LOCATION CORRECTION REQUEST
EUNICE MONUMENT SOUTH UNIT
WELL NO. 624
EUNICE-MONUMENT (G-SA) OIL POOL
LEA COUNTY, NEW MEXICO

AMENDED
Administrative Order NSL-3074

**NEW MEXICO OIL CONSERVATION COMMISSION
WELL LOCATION AND ACREAGE DEDICATION PLAT**

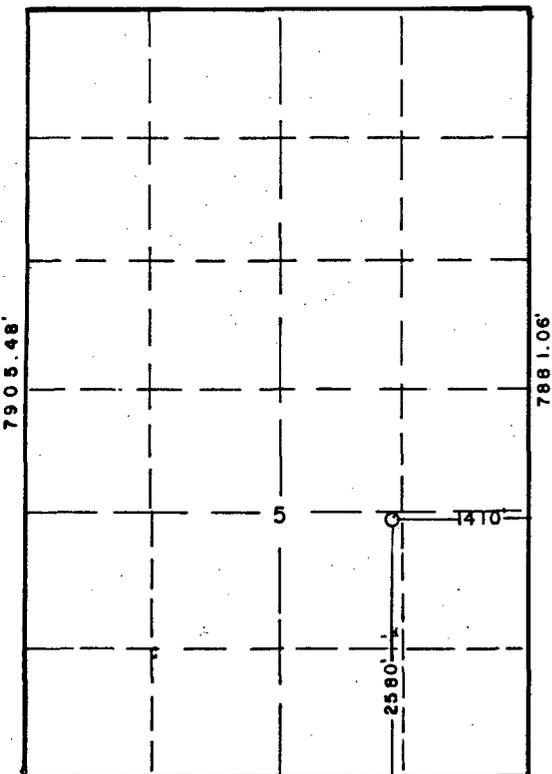
Per your instructions and referencing Division Order NSL-3074 signed on November 8, 1991, please find attached an OCD Form C-102 which shows an ammended location for the proposed EMSU infill Well No. 624 due to a buried pipeline.

The pipeline was discovered while building the drilling pad and site for this subject well. The new location is 1410 feet FEL and 2580 feet FSL, Unit R, Section 5, Township 21 South, Range 36 East, NMPM, Lea County, New Mexico. This ammended location actually becomes more standard as a result of moving it to avoid the pipeline.

Chevron U.S.A. respectfully requests that Order NSL-3074 be ammended to reflect the aforementioned changed location for the subject well. If further information is required please contact me at (915) 687-7246. Thank you.

Said location shall be changed to read, "2580 feet from the South line and 1410 feet from the East line (Unit R) of Section 5, Township 21 South, Range 36 East, NMPM, Lea County, New Mexico".
